Agenda Supplement

May 10, 2023
HDC Meeting

7. 501 N Poplar Street (PID: 07803623)

7. 501 N Poplar Street (PID: 07803623)
HDCRMA-[2022-00775](#)
Fourth Ward
Ryan Baird, Applicant

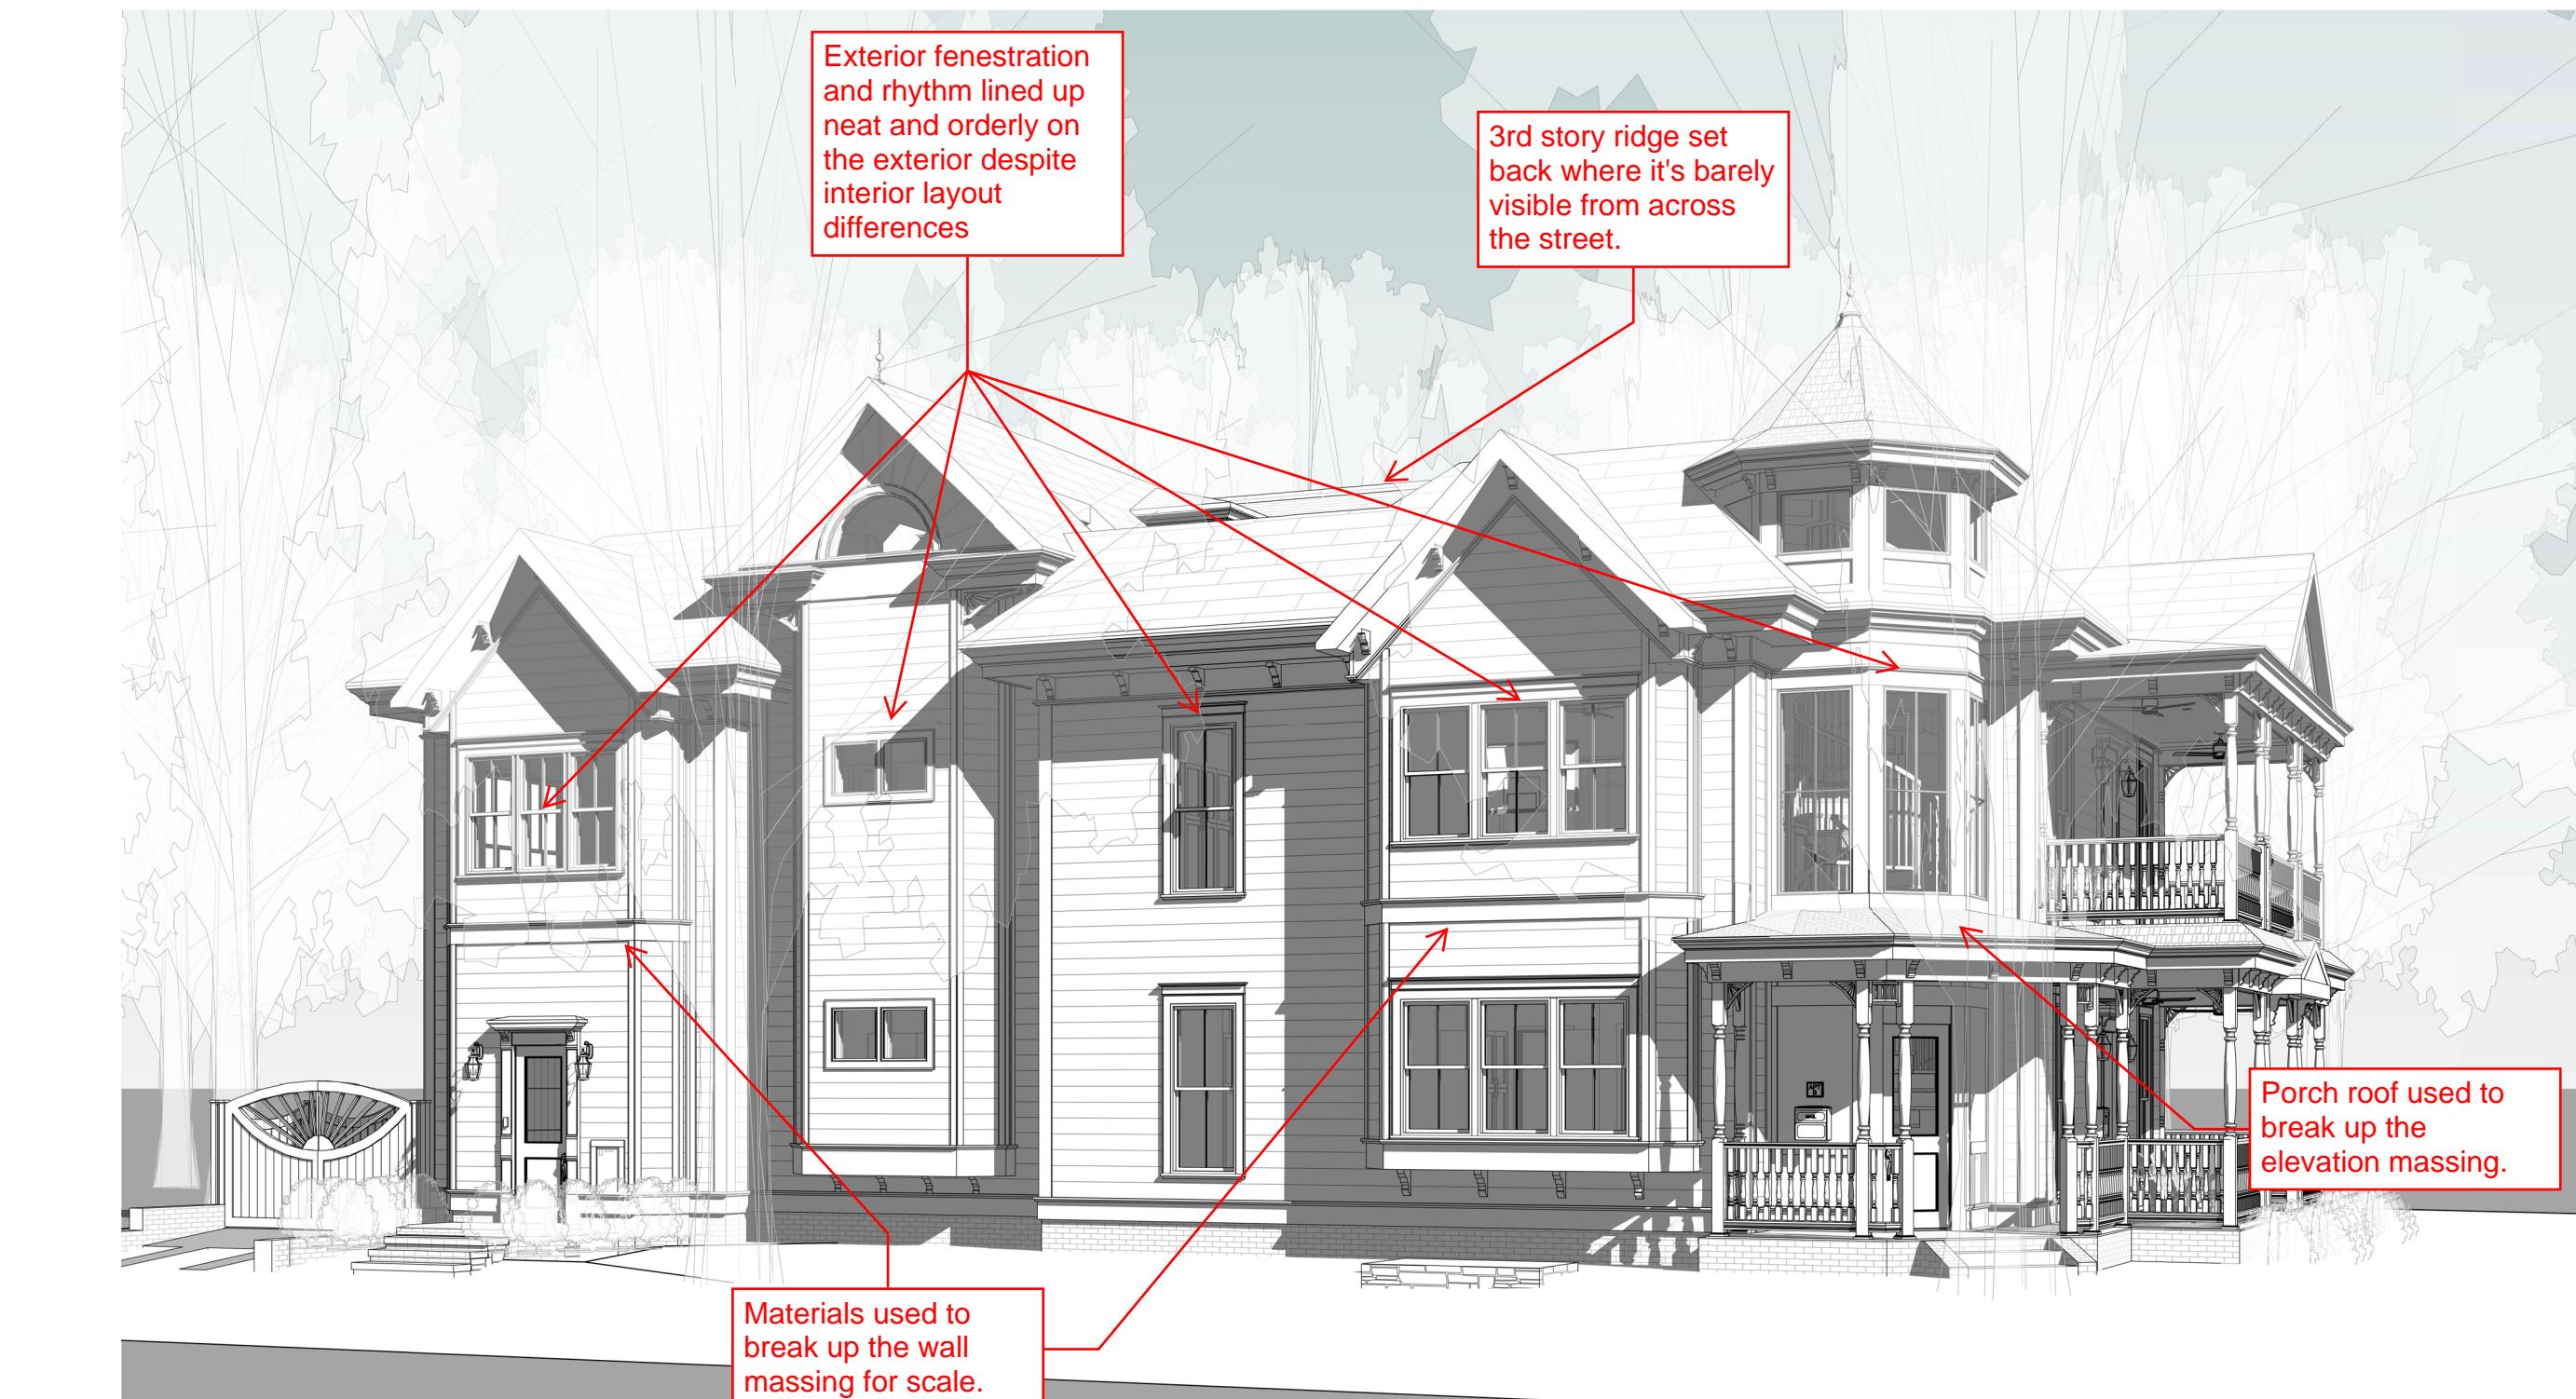
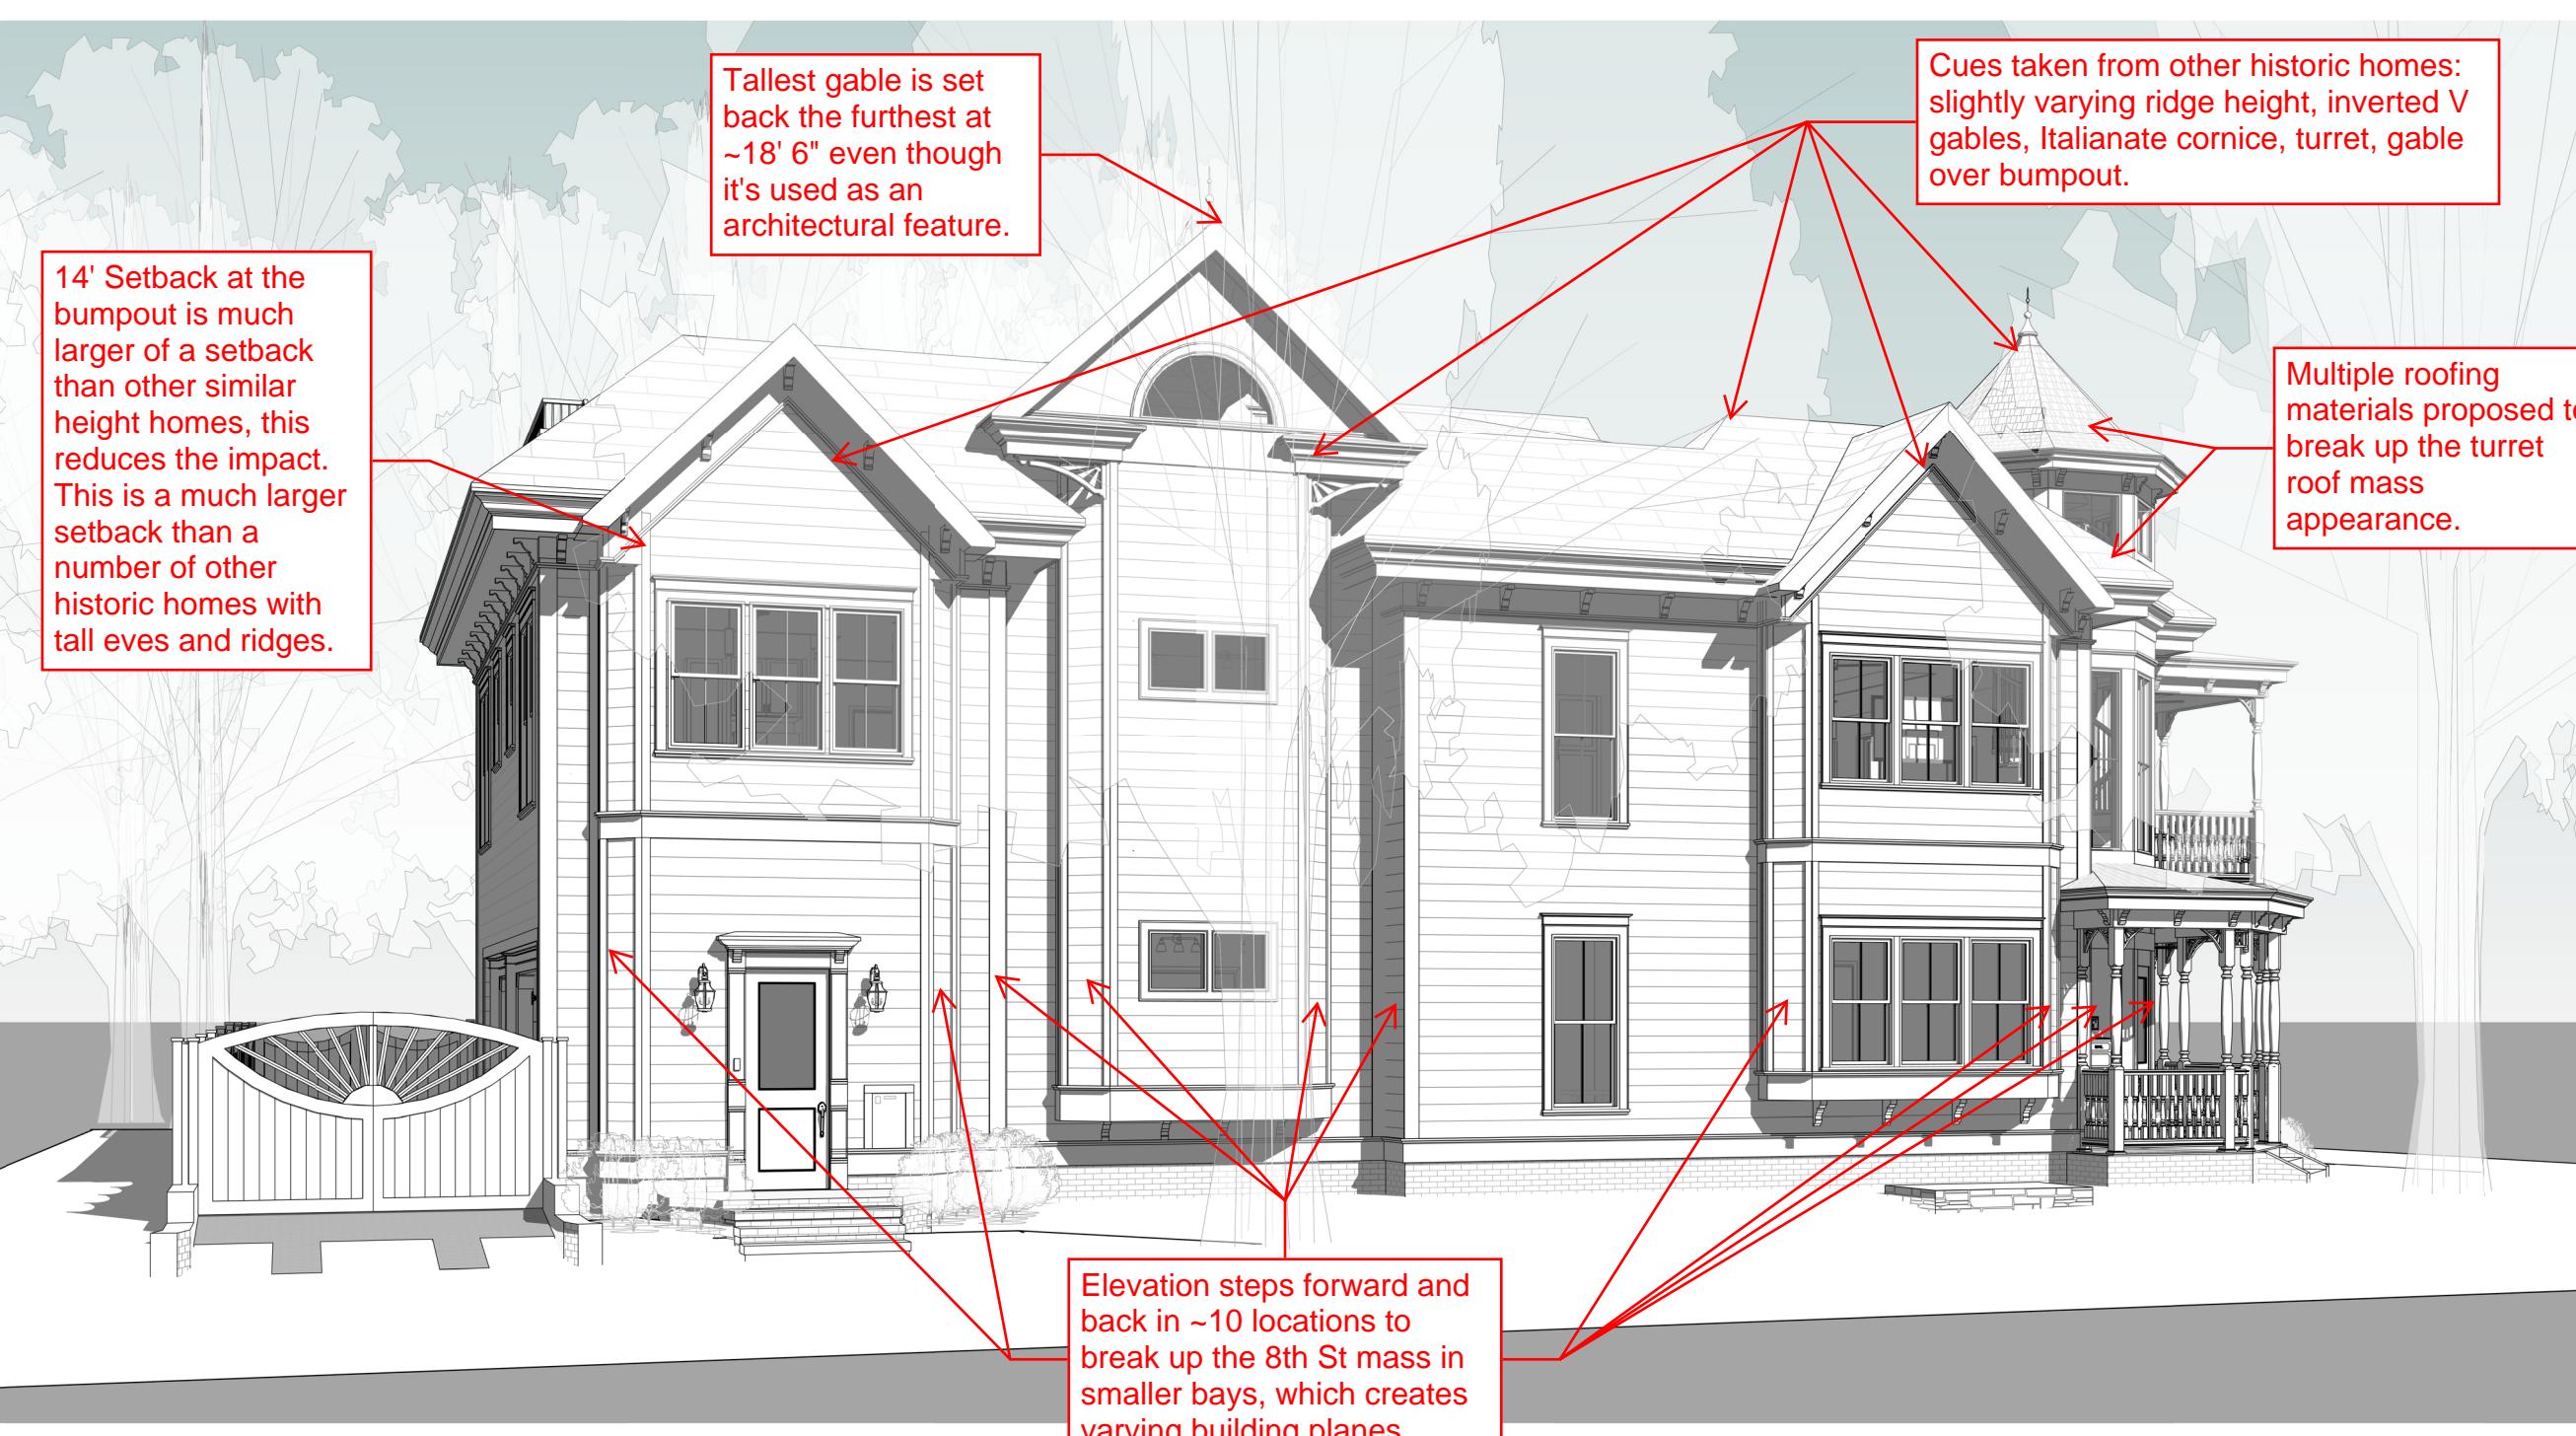
2. Massing, Standard 6.8, number 6.

2. Massing, Standard 6.8, number 6.
6. New buildings should include scale-reducing techniques when the site adjoins historic dwellings. Examples include, but are not limited to, dividing the elevation elements into smaller bays, stepping back taller levels of the new building next to smaller historic structures, varying building planes, breaking up roof masses, using multiple materials, and taking cues from nearby historic buildings.

Site doesn't adjoin historic dwellings, but we've incorporated various scale-reducing techniques regardless.

Numerous cues were taken from nearby historic buildings, see context sheets for numerous examples.

SCALE REDUCING TECHNIQUES SUMMARY

Solar Roof Material Example Images

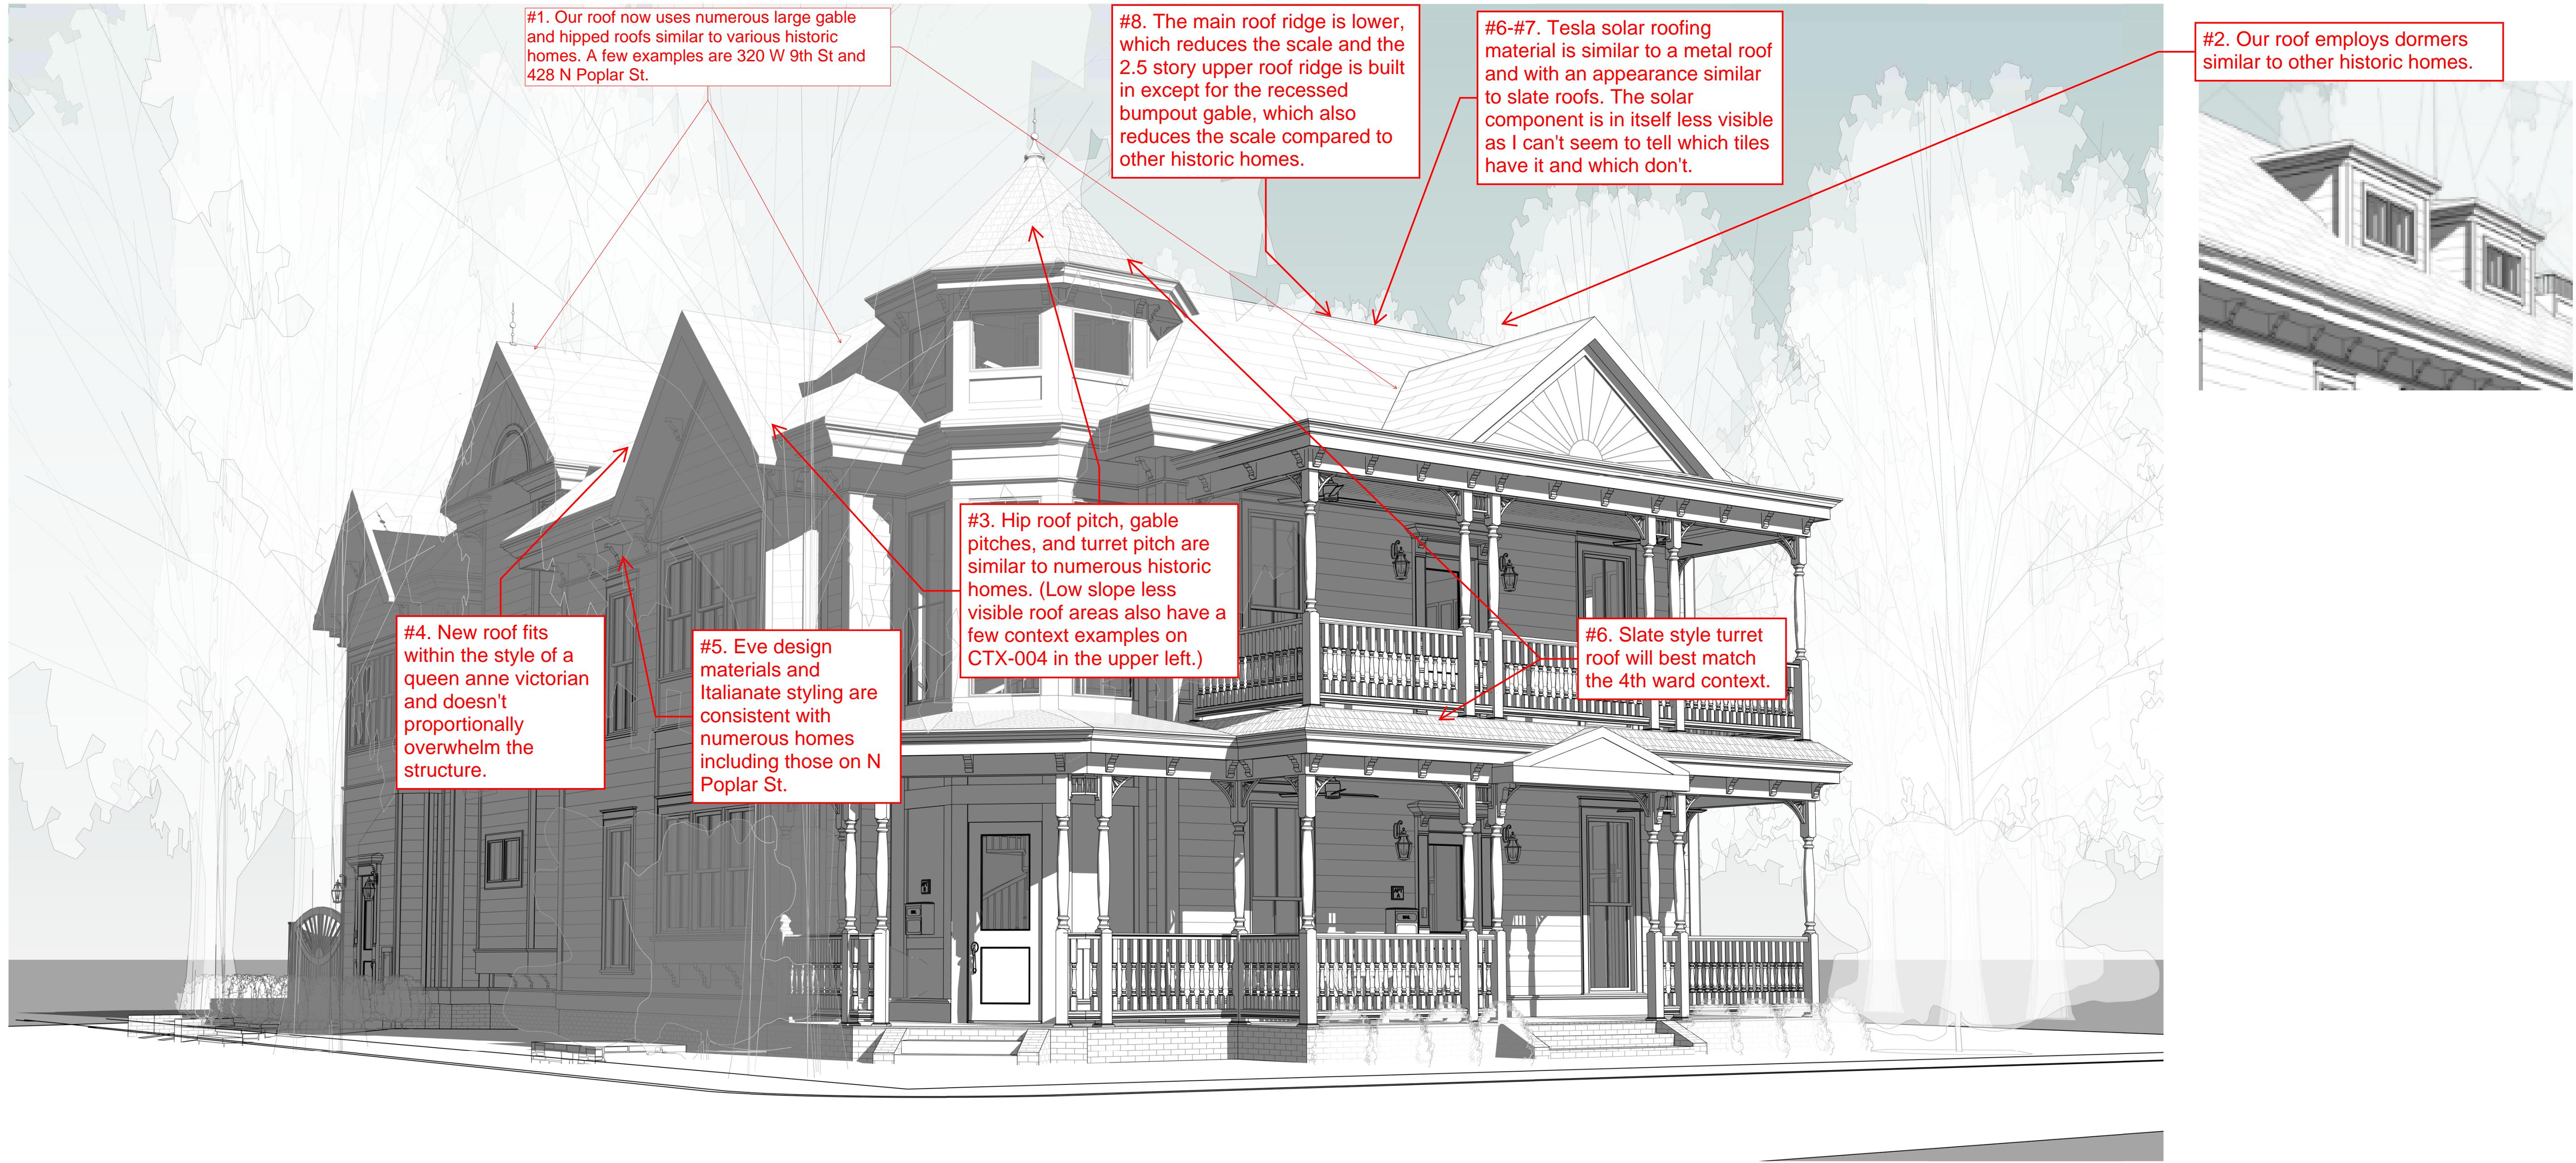
1. Roof forms and materials, per Standard 6.13, numbers 1, 4, 5, 6, 7, and 8.

2nd Video link in the image above.

View last 8 seconds of video for completed roof example.
